# 6 SUB2009-00125

#### LOGSDON SUBDIVISION

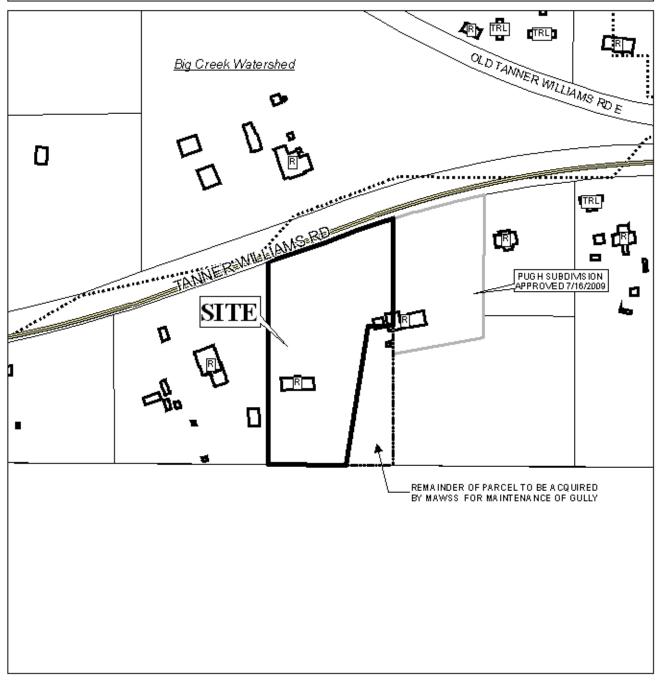
The site fronts Tanner Williams Road, a planned Major Street requiring 100' of right-of-way. Currently, the right-of-way for Tanner Williams Road is only 80' in width; however, as illustrated on the plat, the applicant is prepared to dedicate an additional 10' so as to provide 50' from the centerline of Tanner Williams Road.

The subdivision has approximately 330' of frontage along Tanner Williams Road. As a means of access management, a note should be placed on the final plat stating that the subdivision is limited to one curb cut to Tanner Williams Road, with the size, location, and design to be approved by County Engineering and in conformance with AASHTO standards.

As illustrated on the plat, structures exist on the property; they will not be affected by the proposal.

Based on the preceding, the plat meets the minimum requirements of the Subdivision Regulations and is recommended for Tentative Approval, subject to the following conditions:

- 1) retention of the note on the excluded portion stating that no development shall occur until a legal lot of record is created and adequate frontage on a public street is provided;

- 2) placement of a note on the final plat stating that the subdivision is limited to one curb cut to Tanner Williams Road, with the size, location, and design to be approved by County Engineering and in conformance with AASHTO standards;

- 3) placement of a note on the plat stating that the site must be developed in compliance with all local, state, and Federal regulations regarding endangered, threatened or otherwise protected species;

- 4) placement of a note on the final plat stating that any lots developed commercially and adjoin residentially developed property shall provide a buffer in compliance with Section V.A.8 of the Subdivision Regulations; and

- 5) submission of a letter from a licensed engineer certifying compliance with the City of Mobile's storm water and flood control ordinances to the Mobile County Engineering department and the Planning Section of Mobile Urban Development prior to issuance of any permits.
